Economic Commission for Europe**Inland Transport Committee****Working Party on the Transport of Dangerous Goods****Joint Meeting of Experts on the Regulations annexed to the European Agreement concerning the International Carriage of Dangerous Goods by Inland Waterways (ADN) (ADN Safety Committee)****Twenty-ninth session**

Reports of informal working groups**Proposal for the implementation of the modified explosion protection concept on inland water way vessels****Transmitted by the Central Commission for the Navigation of the Rhine (CCNR)^{1, 2}****I. Introduction**

Zoning on Tank Vessels

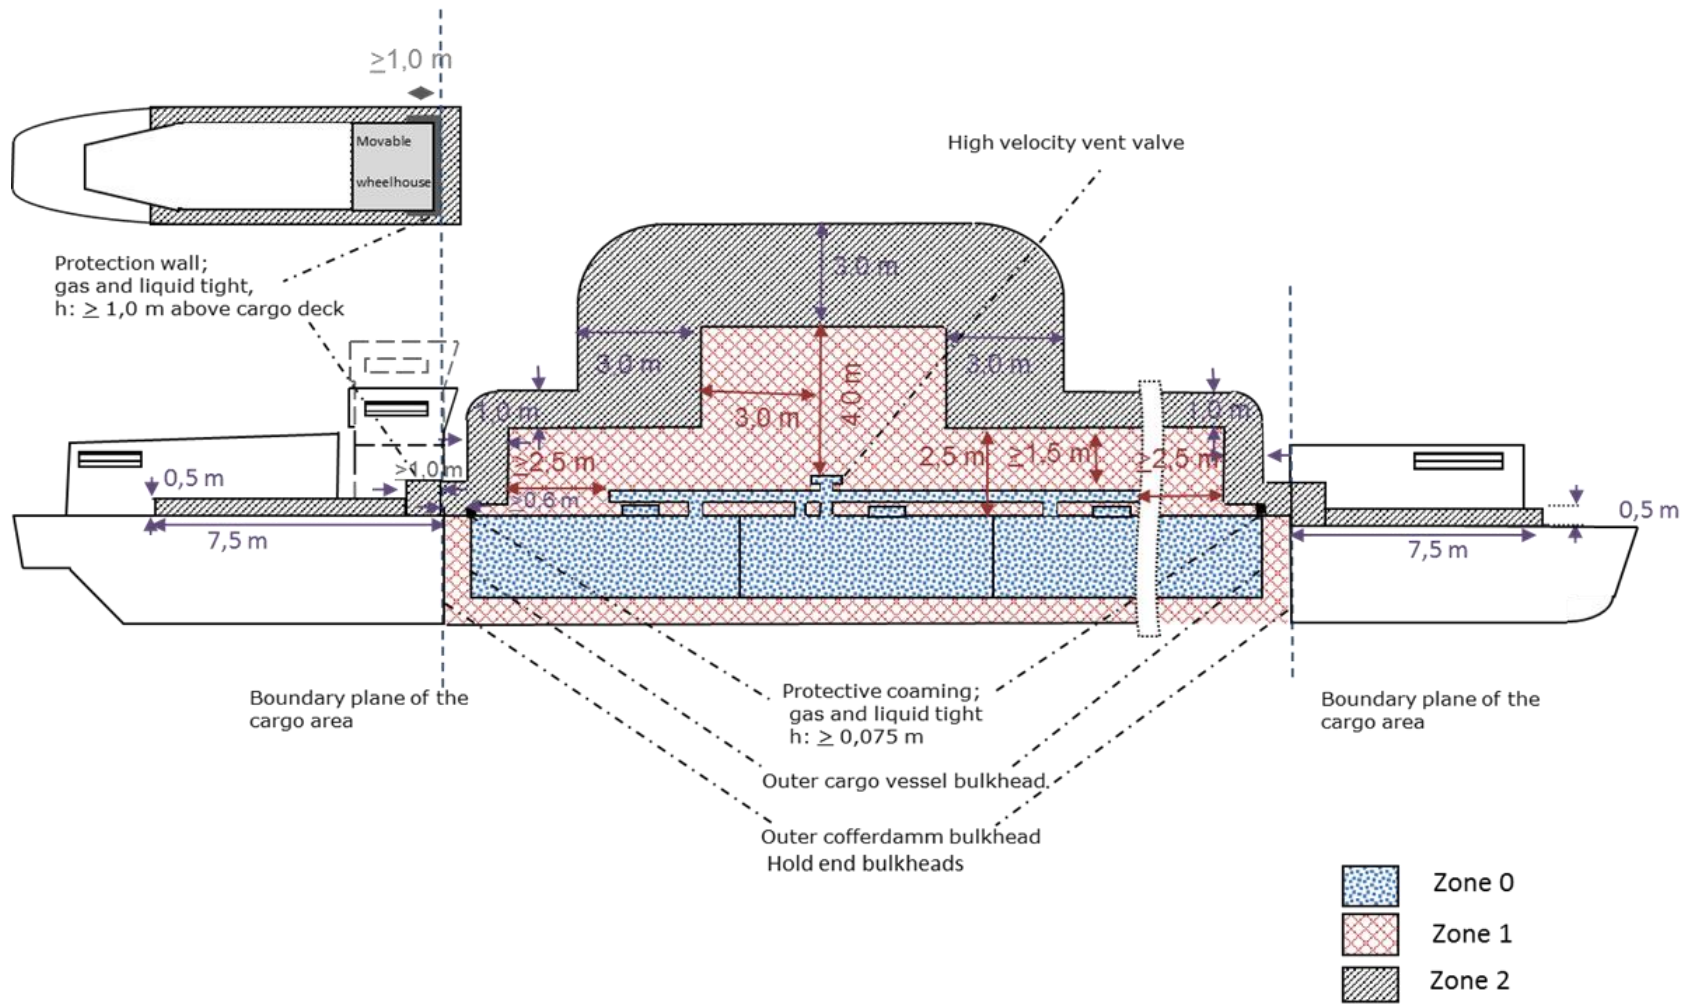
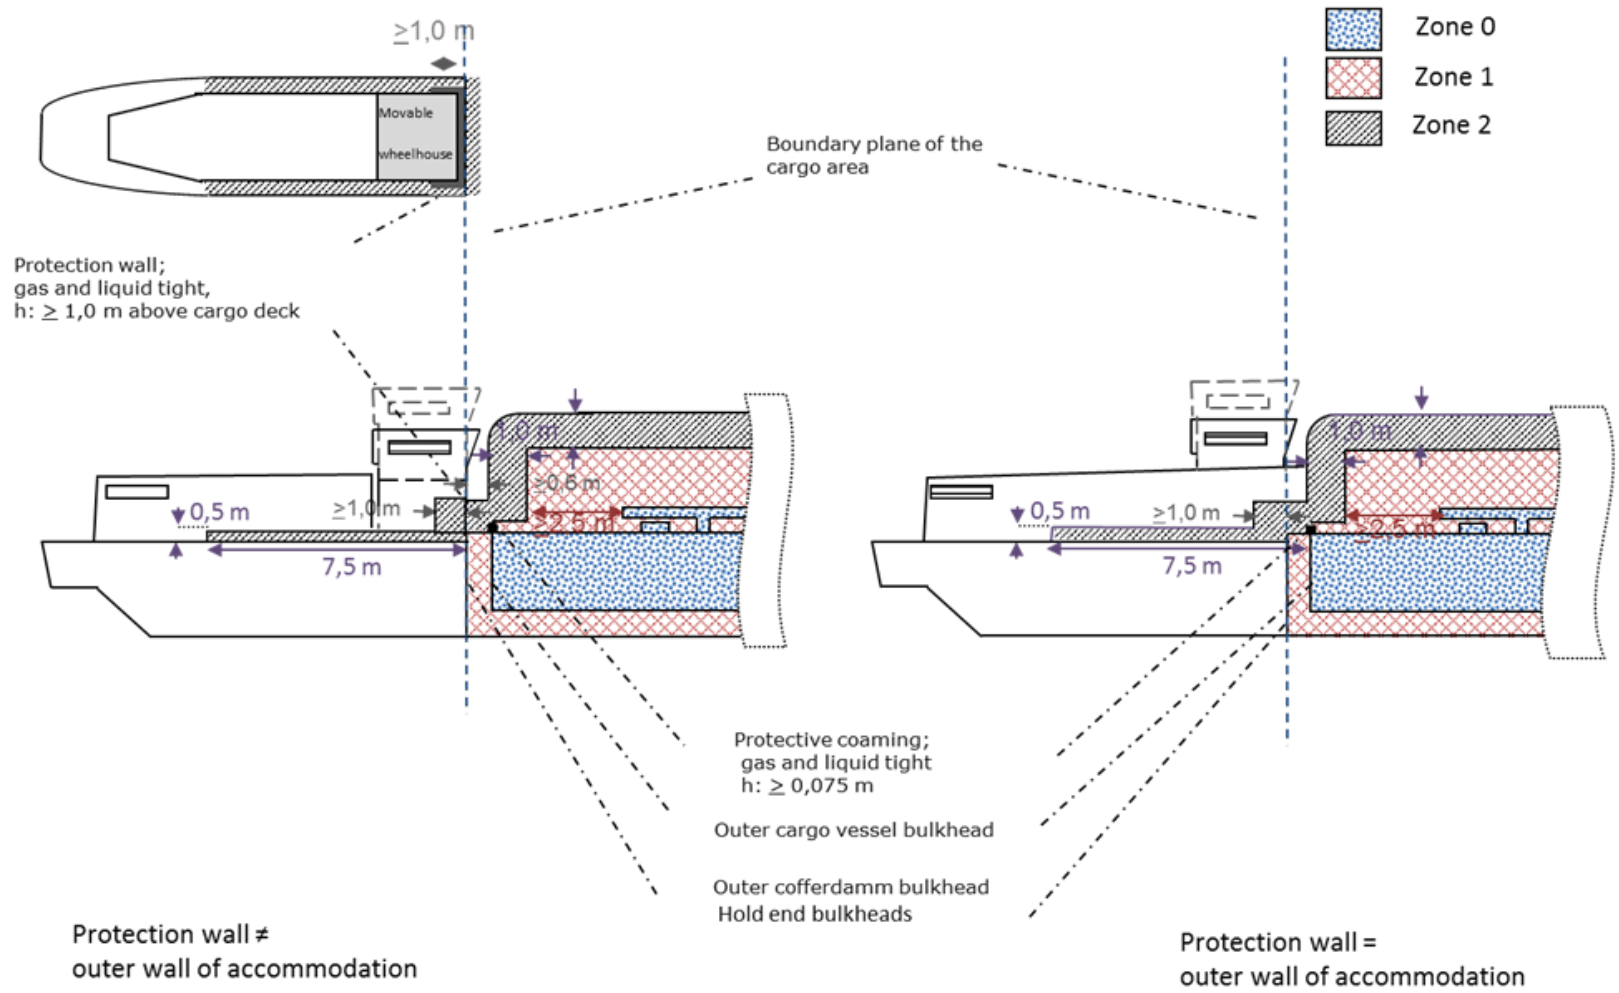
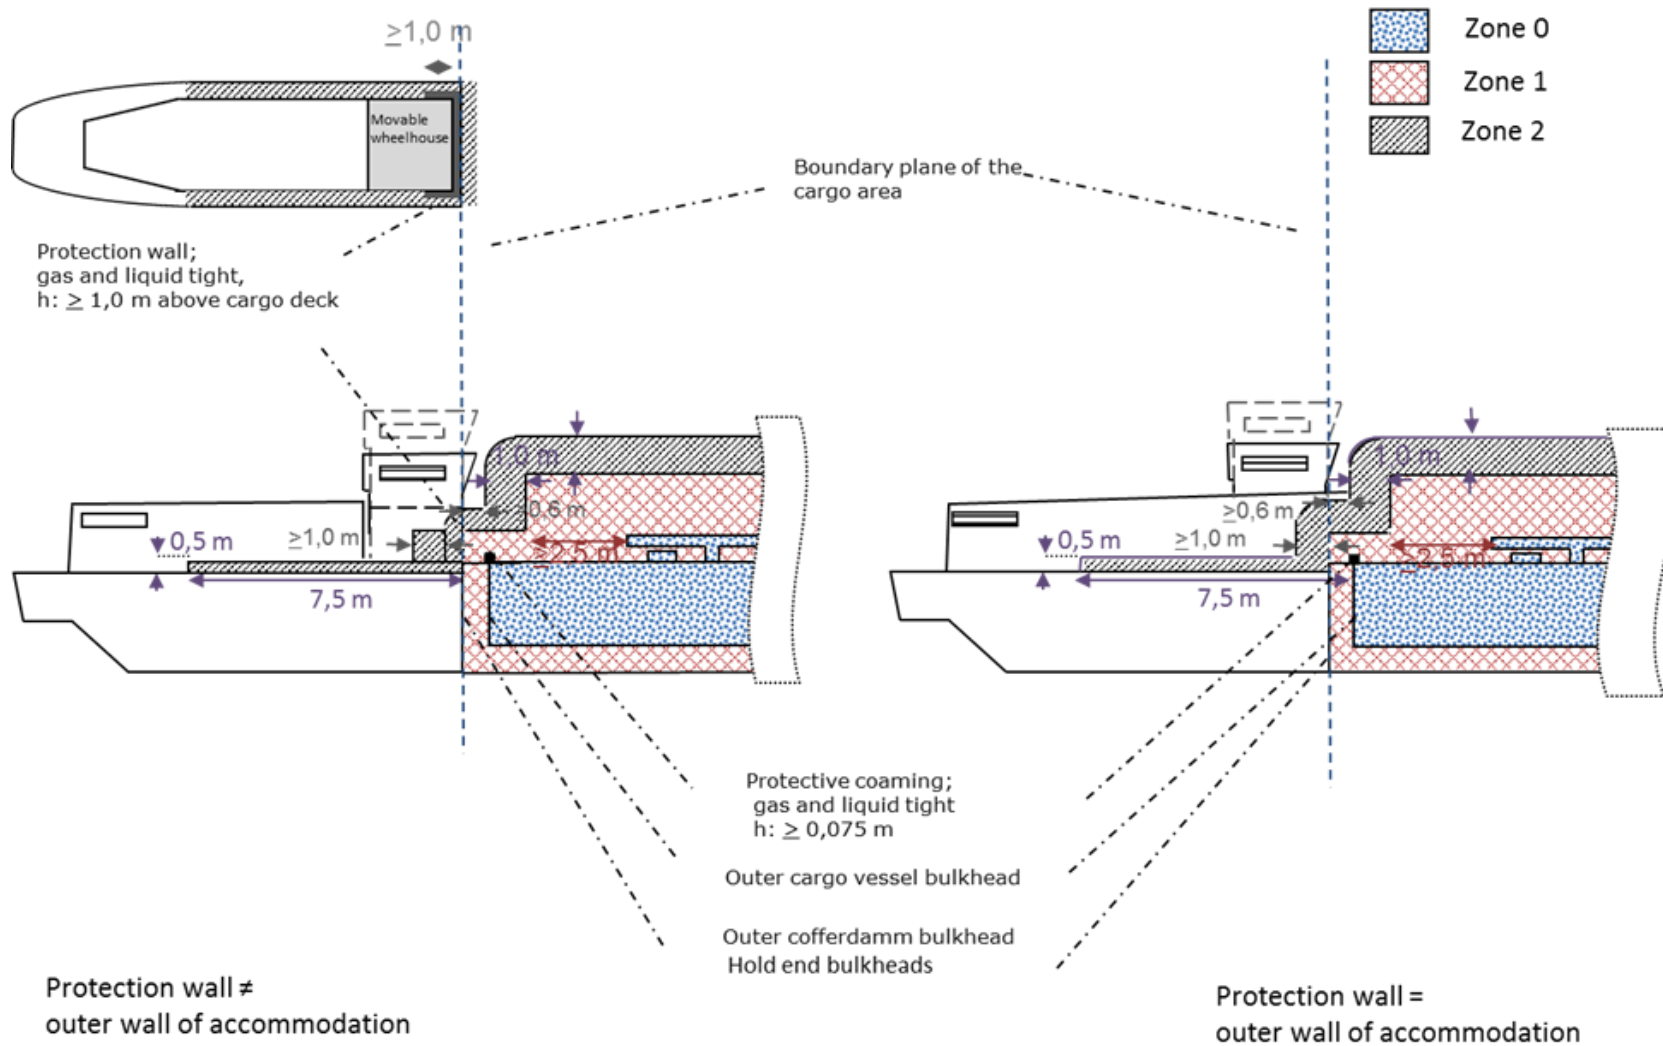
<i>Zoning</i> <i>Classification des zones</i> <i>Zoneneinteilung</i> <i>Классификация зон</i>	<p><u>This zoning (see drawing) applies for tank vessels whose list of substances on the vessel according to 1.16.1.2.5 contains substances for which explosion protection is required in column (17) of Table C of 3.2.3.2</u></p> <p><u>Zone 0:</u> comprises:</p>  <ul style="list-style-type: none"> - <u>Inside all cargo tanks, tank-containers or portable tanks, pipings containing cargoes or cargo vapours including their equipment as well as pumps and compressors.</u> <p><u>Zone 1:</u> comprises:</p>  <ul style="list-style-type: none"> - <u>All compartments within the part of the cargo area below deck being not part of zone 0.</u> - <u>Closed compartments on deck within the cargo area.</u> - <u>The deck from one side of the vessel to the other within the cargo area up to the cofferdam bulkheads.</u> <p><u>Up to a distance of at least 1.6 m to the boundary plane of the cargo area the height is 2.5 m above deck, at least, however, 1.5 m above the highest piping carrying cargoes or cargo vapours.</u></p> <p><u>Whereas every opening in zone 0 except the high velocity vent valves / safety valves of pressurized cargo tanks shall be surrounded by an annulus zone 1 having at least a width of 2.5 m. With openings the diameter of which is less than 0.026 m (1") the distance to the outer cofferdam bulkhead can be reduced to 0.5</u></p>	<p>New zone concept</p> <p>New definition</p>

<i>en, fr, de, ru</i>	<i>Paragraphs</i>	<i>Reason / Explanation</i>
	<p><u>m, provided it is ensured that such an opening is not opened to the atmosphere within this distance.</u></p> <p><u>Adjacent (fore and aft) till the outermost cargo tank tops the height is 0.25 m above deck.</u></p> <p><u>If the ship is build with hold spaces or a cofferdam/ part of a cofferdam is arranged as a service space the adjacent height (fore and aft) till the boundary plane of the cargo area is 1.0 m above deck (see drawing).</u></p> <ul style="list-style-type: none"> - <u>An area surrounding cylindrically the high velocity vent valve/safety valve of pressurized cargo tanks with a radius of 3.0 m up to a height of 4.0 m above the opening of the high velocity vent valve/safety valve of pressurized cargo tanks.</u> - <u>A spherical segment surrounding the ventilation openings of the service spaces located within the cargo area which are actively ventilated, comprising a radius of 1.0 m centered over the opening.</u> <p>Zone 2: comprises:</p> <div style="display: flex; align-items: flex-start;"> <div style="width: 20px; height: 20px; background: repeating-linear-gradient(45deg, transparent, transparent 2px, black 2px, black 4px); margin-right: 10px;"></div> <ul style="list-style-type: none"> - <u>An area on deck of 1.0 m in height and length following zone 1.</u> - <u>On the fore deck and the aft deck an area of the entire width of the vessel adjacent to boundary plane of the cargo area, with a complete length of 7.5 m. Between the lateral side of the vessel and the protection wall this area equals the length and height of the dimensions of the lateral side of the protection wall. Apart from that, the height is 0.5 m.</u> <p><u>This part is not part of zone 2 in case the protection wall extends from one side of the vessel to the other and there are no openings.</u></p> <ul style="list-style-type: none"> - <u>An area following zone 1 around the high velocity vent valve/safety valve of pressure cargo tanks having an expansion of 3.0 m.</u> - <u>A spherical segment following zone 1 which surrounds the ventilation openings of the service spaces located within the cargo area which are actively ventilated, comprising a radius of 1.0m centred over the opening.</u> </div>
